Errata SLG46517 CE-GP-001

This document contains the known errata for SLG46517 and the recommended workarounds.

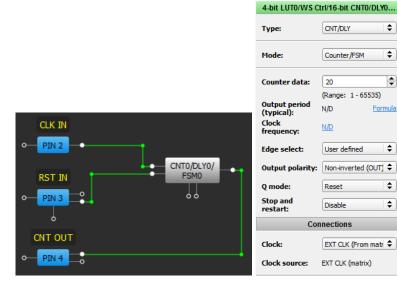
After the Reset.

If the Counter Reset is asserted at the same time as a rising clock edge, it is possible that the Counter Data will be reset incorrectly and the counter output may appear faster than expected. This phenomenon appears more often as the clock frequency increases.

Synchronize RESET input of the Counter with its CLK using 2 DFF cells as shown on Figure 3.

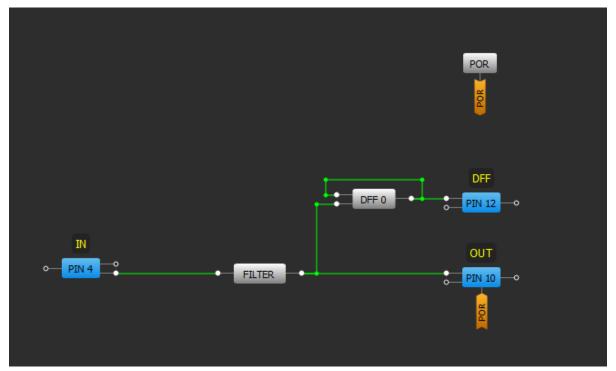
When clock type is high frequency.

If clock type high frequency input comes in, the FILTER cell may not filter out it. There are several factors like input frequency, duty cycle and LOW duration in such signal that may lead to its passing through FILTER block.

Currently there is no workaround for this issue. Filter block is good at filtering short spontaneous glitches. It is intended to be used in series connection before the delay cell to avoid its latching.

Figure 5

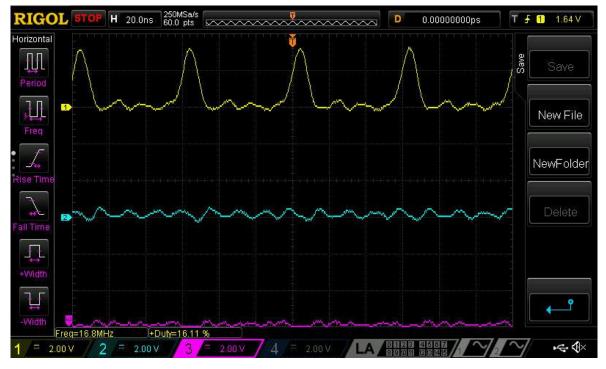
1. Period is 60ns. Pulse width is 10ns DC=16.7% (Correct functionality)

Figure 9

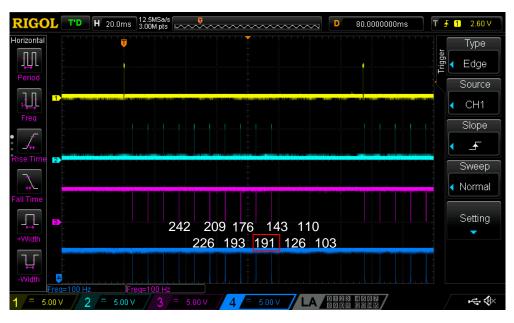
The example data capture below shows ten periodic I2C reads of CNT2/DLY2 configured to count down at about 16 clocks per read. The sixth read sample erroneously shows a value greater than that of the fifth. The seventh sample reads as if the previous I2C error never occurred - the difference from the fifth sample (176) to the seventh (143) is 33 clocks or 16 clocks + 17 clocks as expected.

If the possibility of incorrect I2C data reads can't be accommodated for by external software checks, one can guarantee proper operation by stopping the CNT/DLY block's clock during I2C reads

Figure 10: I2C Write of 16-Bit Counter Data Example

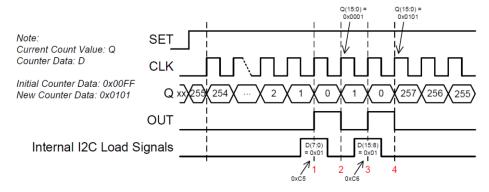
The timing diagram in Figure 10 sets up a case where an improper output will be seen on the counter. In this example, the initial Counter Data value (D) is set up as 0x00FF. As you can see, the Current Count Value (Q) decrements from 255 down to 0 with rising edges on CLK. At time "1" denoted by a red number 1, an I2C command (not shown) has just been sent to the GreenPAK device to reconfigure the Counter Data value to 0x0101.

As previously mentioned, the 16-bit value is loaded from the I2C buffers to the Counter Data registers in 8-bit chunks. Right at time "1", the LSB byte (0x01) is loaded into the Counter Data registers. This makes the Counter Data value temporarily equal to 0x0001. At time "2" between the internal I2C load signals, the counter receives a rising edge on its clock input. This causes the Current Count Value to underflow and to be loaded with the Counter Data value which is 0x0001. At time "3", the MSB byte (0x01) is loaded into the Counter Data registers setting the Counter Data value to 0x0101. At time "4", the Current Count Value underflows again and is set to the Counter Data value of 0x0101.

Figure 11: 16-Bit I2C Counter Block Diagram

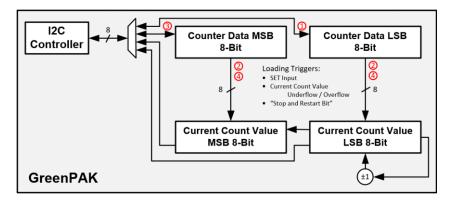
This behavior results in two output pulses on OUT when only one pulse is expected. Observing this behavior depends upon the asynchronous timing between the counter's clock and the I2C write command to the Counter Data registers. For some applications, the extra pulse on OUT can be ignored and the counter will self-correct after underflowing, overflowing, or being SET/RESET through the GreenPAK connection matrix.

Figure 11

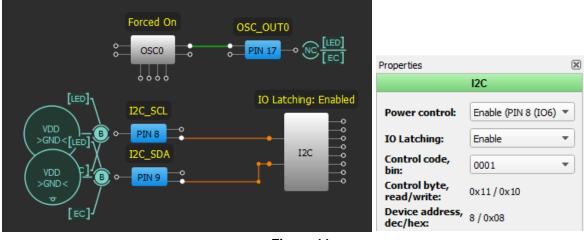
In the example below, we will be monitoring the OSC output, which is measured by a scope on Channel 3 via PIN17 ("OSC_OUT0"). The I2C bus will be forced low to create a START bit.

By toggling I2C_SDA low and then I2C_SCL low, the GreenPAK registers this as a start bit and latches all General Purpose Outputs such as PIN#17("OSC_OUT0"). In the Figure 12, notice that PIN#17 (OSC_OUT0) stops toggling.

Disable IO Latching in programmed OTP. This register is I2C-write locked during normal operation and therefore should be disabled in configuration file.

Figure 13. Test Design

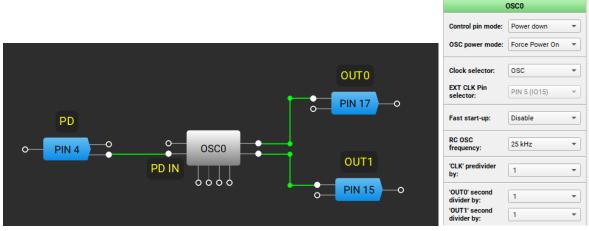
If a pulse with a duration of less than ~40 ns is applied to the PWR DOWN input of the oscillator, the oscillator outputs remain stuck for milliseconds, as shown in figures below. The issue is observed for all available oscillators.

Change Fast start-up setting to Enable or omit applying glitches at PWR DOWN input in OSC.
